Ref: Docket No. 70-925; License No. SNM-928
Response to NRC Comments: "Cimarron Corporation Radiation Protection
Plan (Annex A)"

**Response to NRC Comments on the
Cimarron Corporation Radiation
Protection Plan (Annex A) for the
Former Nuclear Fuels Fabrication Facility
near Crescent, Oklahoma,
Dated September 19, 1996**

**License No. SNM-928
Docket No. 70-0925**

January 2, 1997

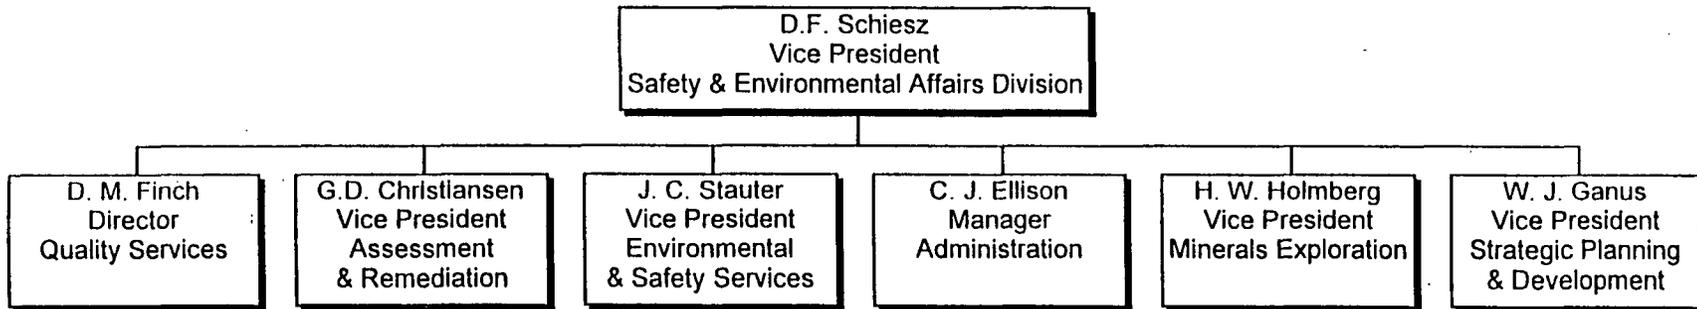
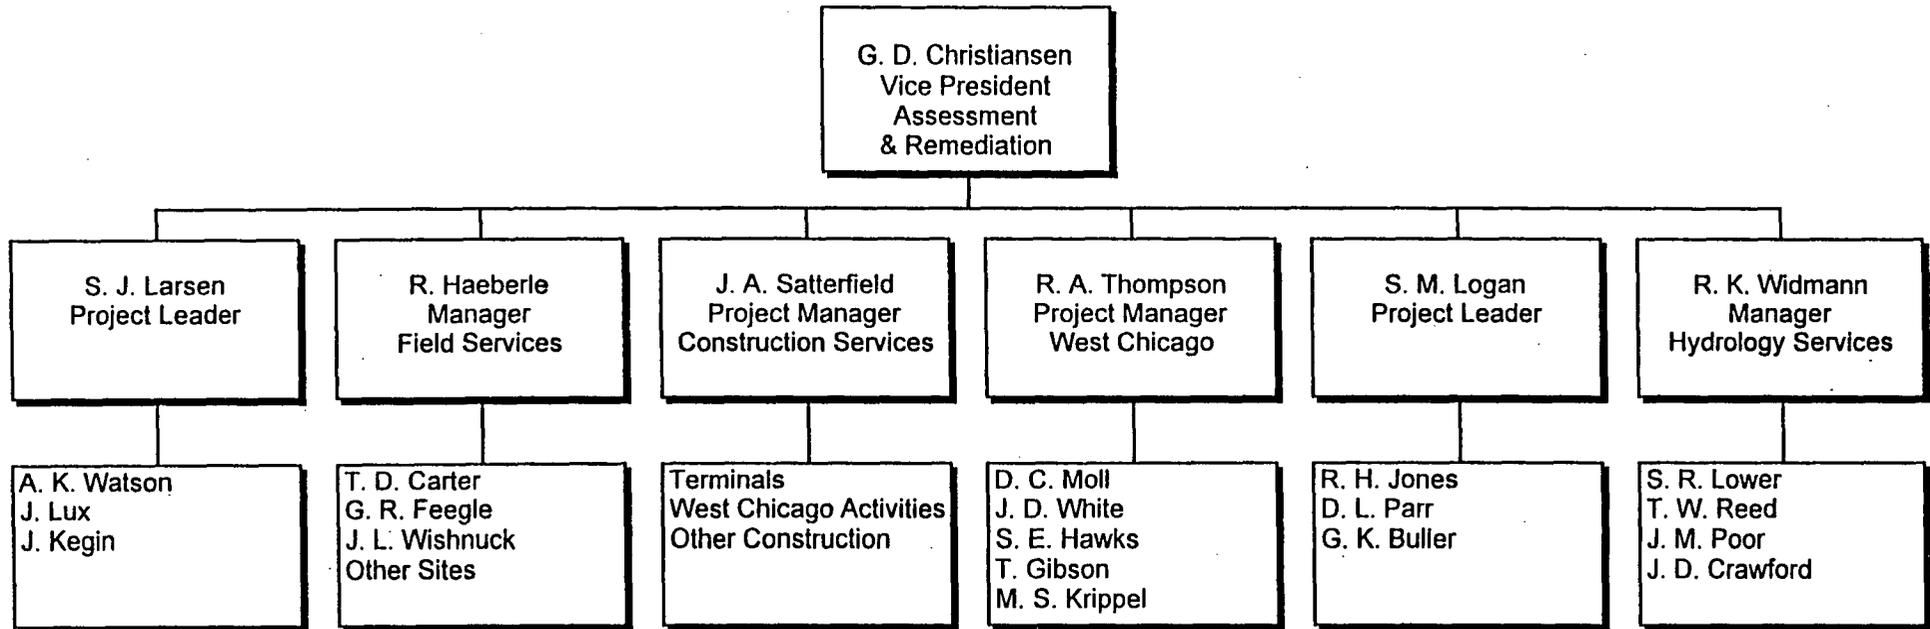
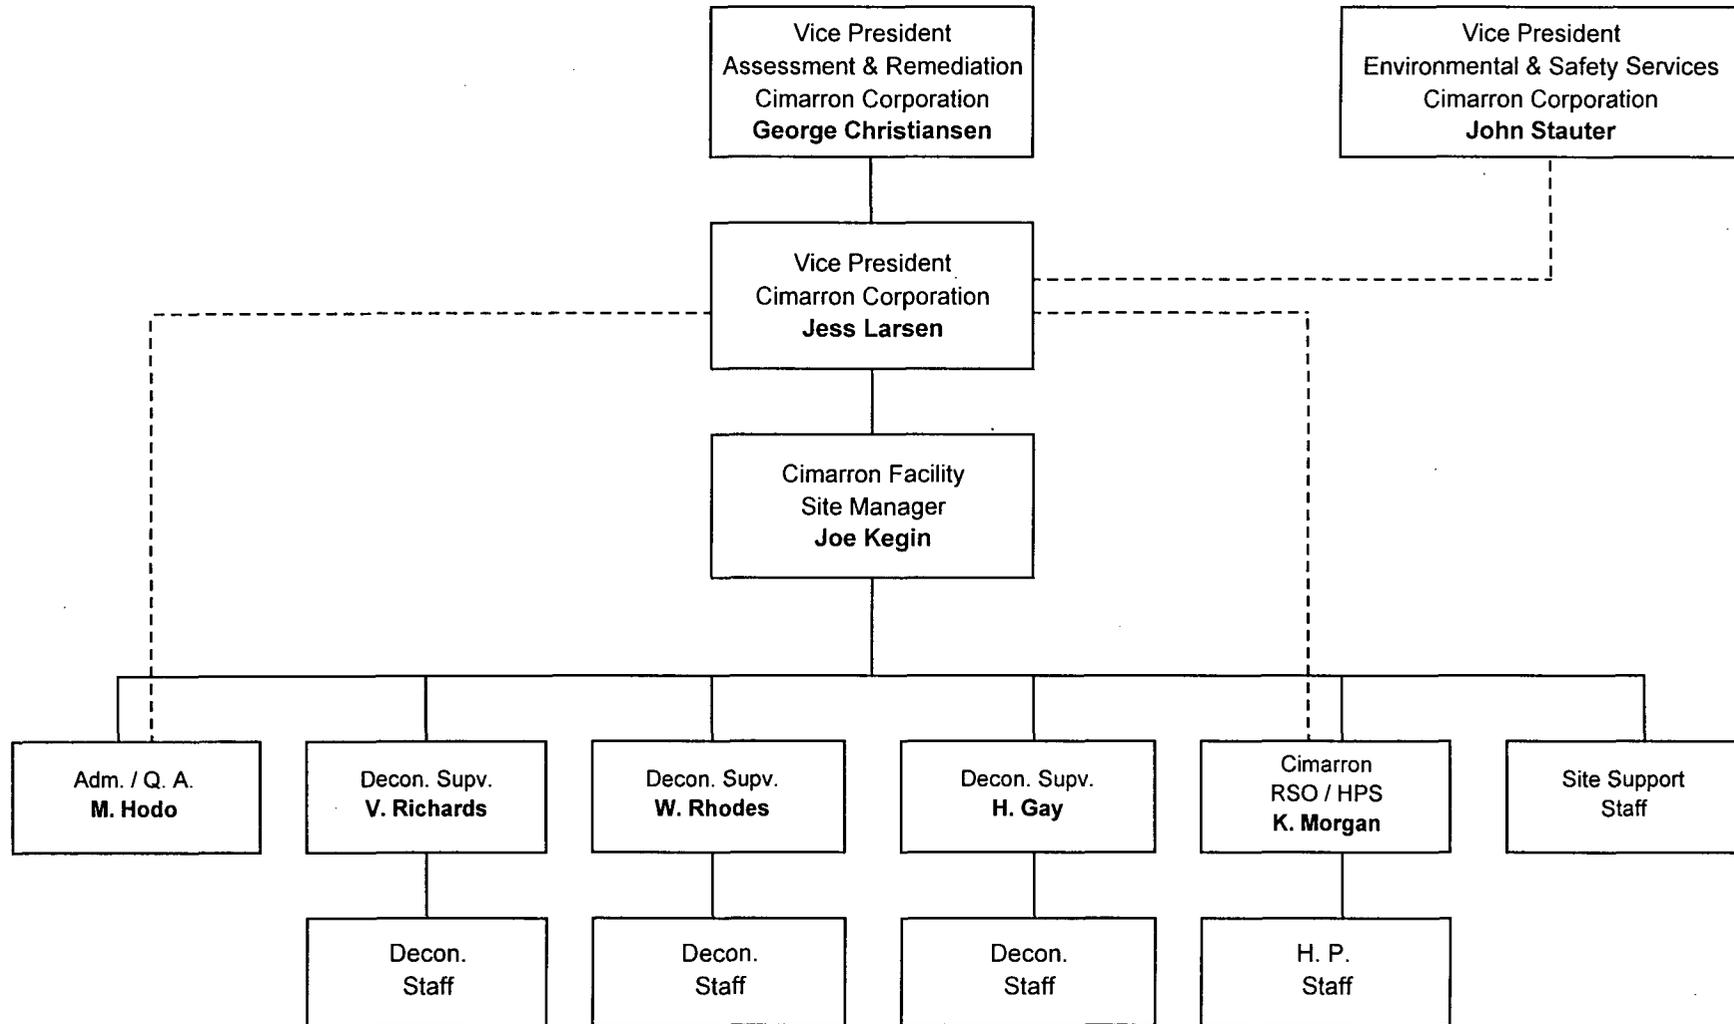
An organizational chart illustrating the organizational structure to carry out the objectives of the radiation protection plan should be included in this section.

Section 3.0 of Annex A has been revised to include organizational charts (see Attachment # 2).

The current organizational structure for Cimarron Corporation, including relationships between Cimarron Corporation and Kerr-McGee Corporation, is presented in Figures 3-1 through 3-3. Changes to the Radiation Protection Organization require the approval of the Vice President, Cimarron Corporation. Radiation Protection staffing levels shall be periodically reviewed by the Vice President, Cimarron Corporation, Site Manager, and Radiation Safety Officer, as applicable, to ensure that adequate staffing levels are maintained which are consistent with current and planned activities. Duties and responsibilities that are required for each health physics procedure shall be clearly defined.

Figure 15-1
Cimarron Corporation
Air Sampling Locations

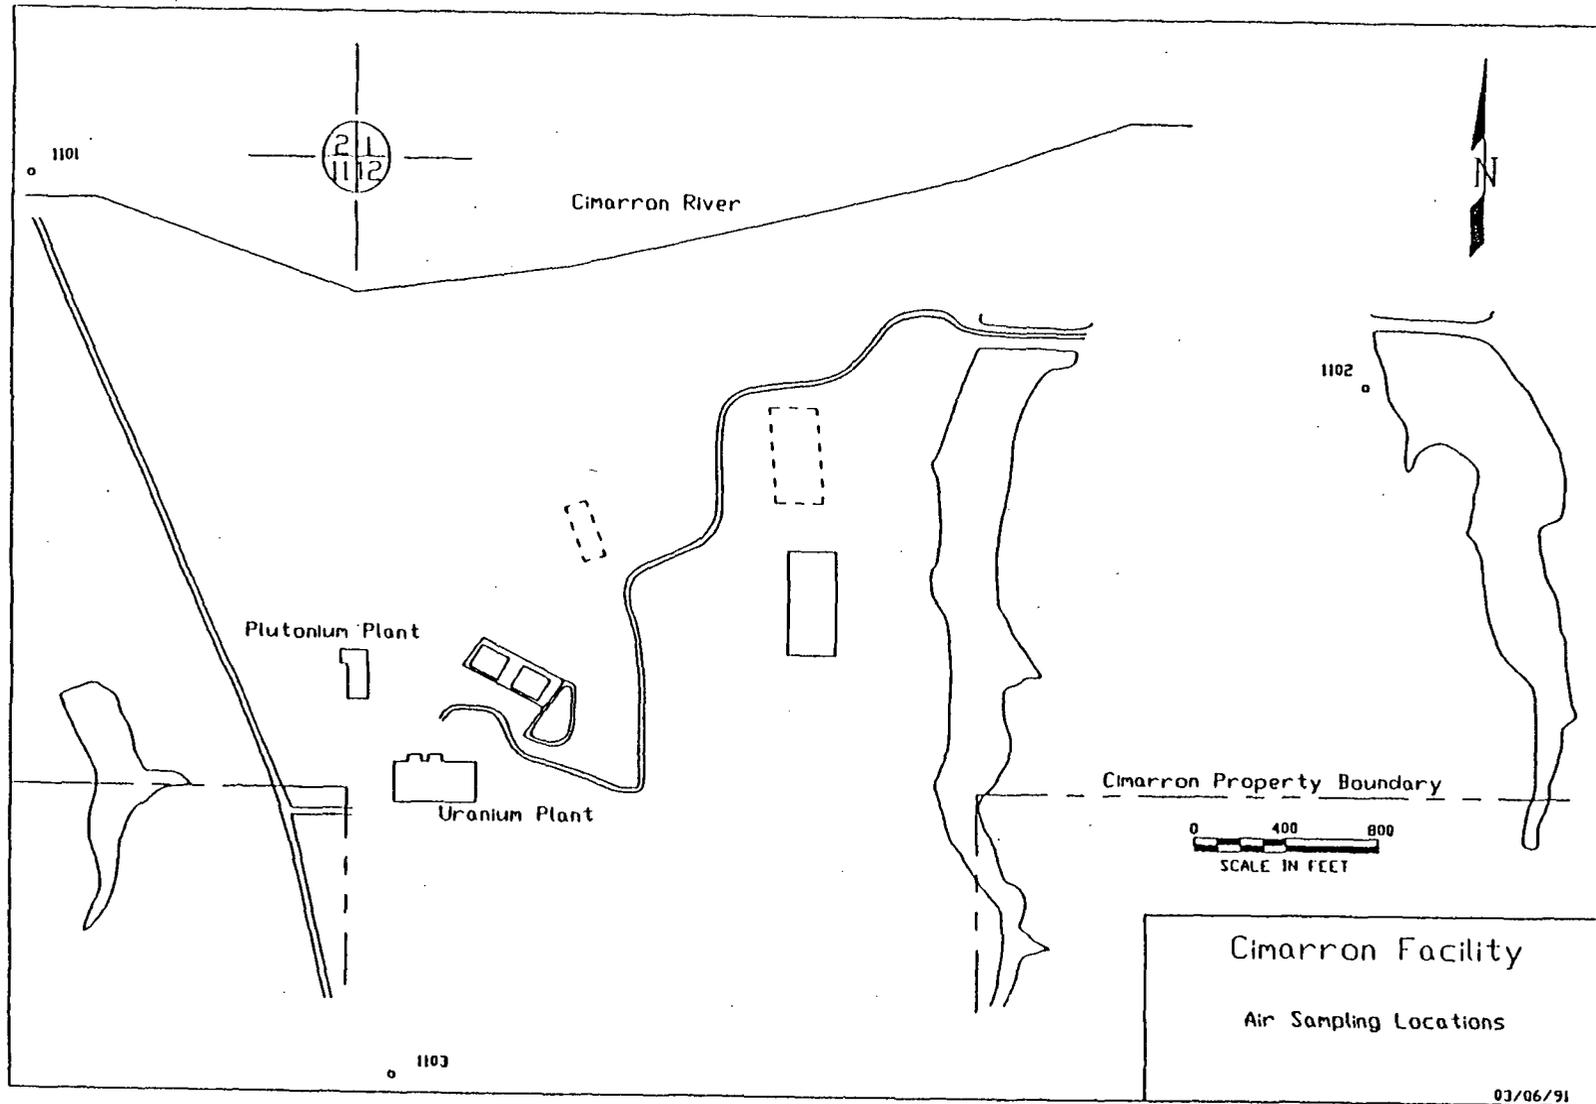
This section should list the administrative limits for each type of environmental sample collected and the action required should an environmental pathway exposure exceed the limit. Also, please ensure that the radiation protection plan includes the monitoring location (i.e., diagram), type of instrumentation to be used, the minimal detectable activity of the measurement technique and the isotopes that are to be measured for each type of environmental pathway measured.

Section 15.0 of Annex A (see Attachment #9) has been modified to incorporate NRC comments.

Environmental air samples are collected approximately weekly at three locations. Samples are analyzed for gross alpha and gross beta activity. The air monitoring program, along with action levels, is summarized on Table 15-1. Figure 15-1 shows the location of the samplers.

DRWN. BY: JE	DATE: 12/30/96	SCALE: NONE
JOB NO.	DRAWING NO. 96MOST-RF2	REV. 0

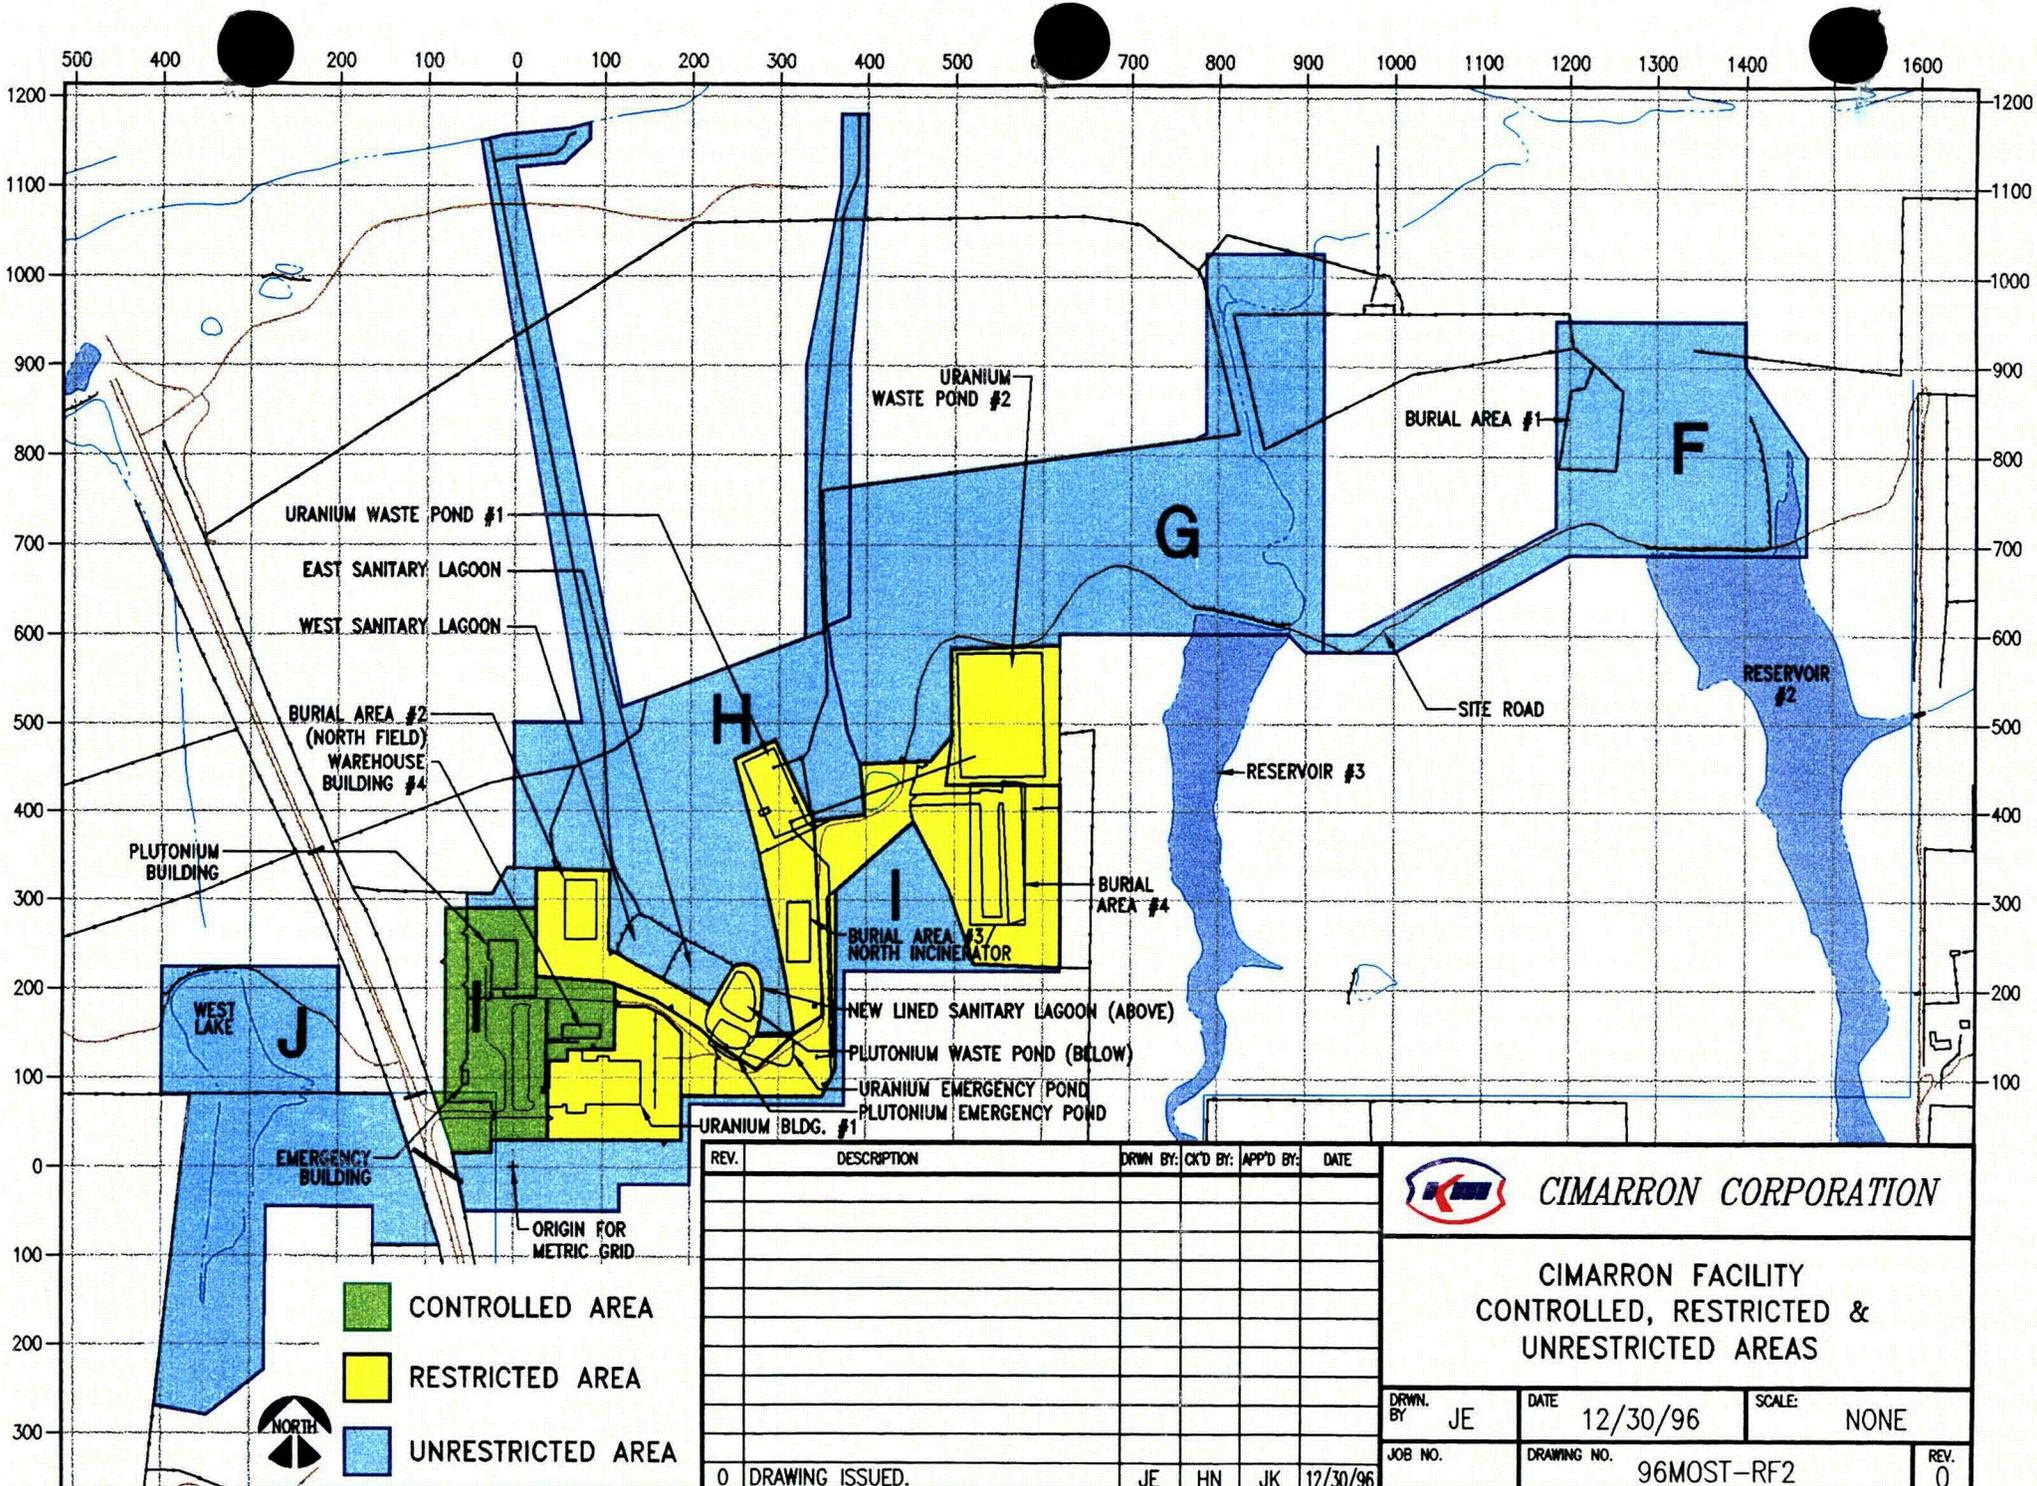
Please include diagrams of the site that illustrate Controlled Areas, Restricted/Radiologically Controlled Areas, and Unrestricted Areas. Also, please describe, in the plan, the posting that will be used to designate areas in accordance with 10 CFR 20.1902, "Posting Requirements."

Drawing number 96MOST-RF2, attached, shows areas that are currently designated as Controlled, Restricted, and Unrestricted Areas. Section 8.0 of Annex A has been revised (see Attachment #4) to incorporate Section 8.5 which specifically addresses posting requirements.
